# CITY OF MADISON Proposed Certified Survey

Plat Name: Johnson CSM

Location: 3034 Shady Oak Lane  
Scott Johnson/

# CERTIFIED SURVEY MAP

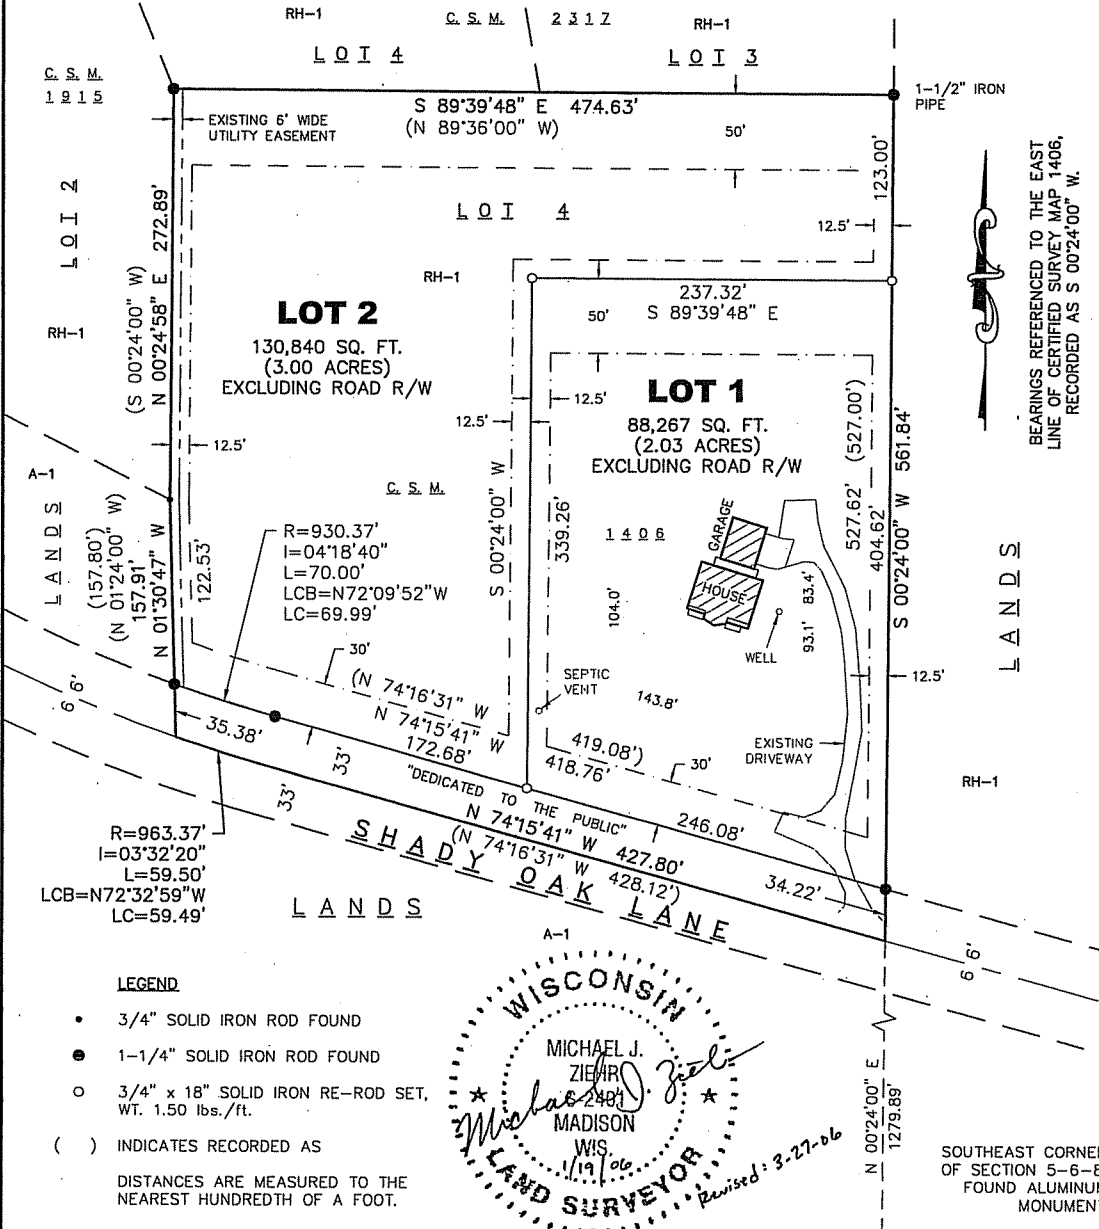
Check with him if you can. My concern would be the potential impacts on future urban development of those two lots. Yes, there is topography to contend with, especially right off the road, but the potential for some 90-foot deep urban/ TND lots fronting onto a 56-60 foot wide R/W some time in the future cannot be ignored. I also don't like people wrapping around other people's tracts for neighbor-relation reasons. -TIM

Quick question: Why does that Lot 2 jog around Lot 1? It would make it a lot easier to recommend in favor of this application if the new line went straight back from the road. Would your clients have heartburn about this? Please advise!

The owner would really like to keep the lot layout as submitted to the City. This was his parents land and there is a big garden with raspberry bushes and fruit trees up in the northeast corner of this property. That is why the lots got configured the way they did. Apparently one of the kids is going to be deeded proposed Lot 2 of the C.S.M. and really wants to keep that area on their property. Apparently Lot 1 with the existing house would then be sold off. What do you think? There was some miscommunication between family members that is why it took this long to get back to you, so I apologize. I know the Town and the County have approved the C.S.M. the way it was submitted to the City back in April with the "L" shaped lot. Do you know of another way for him to keep his garden on his property and yet meet the Cities requirements? Let me know, talk to you soon....Thanks.

The original proposal we submitted to the County and Town had the line going straight back to the rear lot line. Then the owner said he did not want to create the land division, then he came back and said he wanted to re-submit it with the lots as shown on this submittal to you. This layout is the layout approved by the County and Town, so that is where it stands right now. Are you telling me the City will not approve his map as submitted? I could check with him if you want me to, I am not sure of his reasoning behind the current lot configuration. Let me know. Thanks.
